# DAIMLER

On August 24, 2020 DTNA identified an issue affecting Freightliner, Western Star and FCCC models equipped with ConMet flat rotor disk brakes and aluminum hubs. Rotor mounting studs installed on steer and drive hubs on vehicles with flat rotors built from May 1, 2020 through August 24, 2020 may fracture due to hydrogen embrittlement. Initial inspection data indicates approximately 1% of the mounting studs may fail. Table 1 lists the affected hub assemblies.

Figure 1. Rotor mounting stud fracture due to hydrogen embrittlement

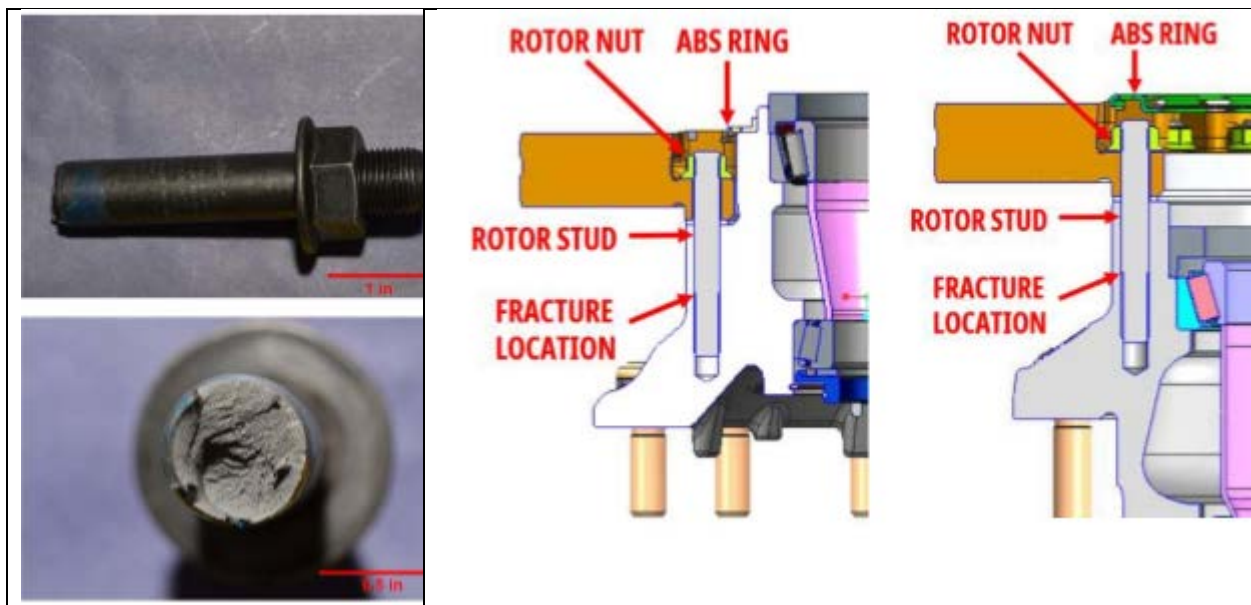
When hydrogen embrittlement affects the rotor mounting stud fracture of the stud occurs 1 to 24 hours after torqueing of the stud - see Figure 1. Fracture of the stud occurs approximately 1.7 inches (43.2 mm) below the rotor mounting surface. A fractured stud could dislodge from the hub mounting hole however the stud will be captured by the ABS tone ring - see Figure 2. As damage progresses damage to the ABS tone ring, ABS sensor, and caliper anchor plate may occur. Drivers may notice wheel end noise, vibration, or an ABS indicator light - see Figure 3. Based on engineering, test and field information vehicle safety is not compromised.

possible. To check the stud a torque of 40 ft-lb (54.2 Nm) needs to be applied to the rotor mounting stud. If the rotor mounting nut or stud turn the stud has likely fractured. If a fractured rotor stud is discovered then the wheel end should be replaced. If no fractured studs are discovered then the wheel end may be reused.
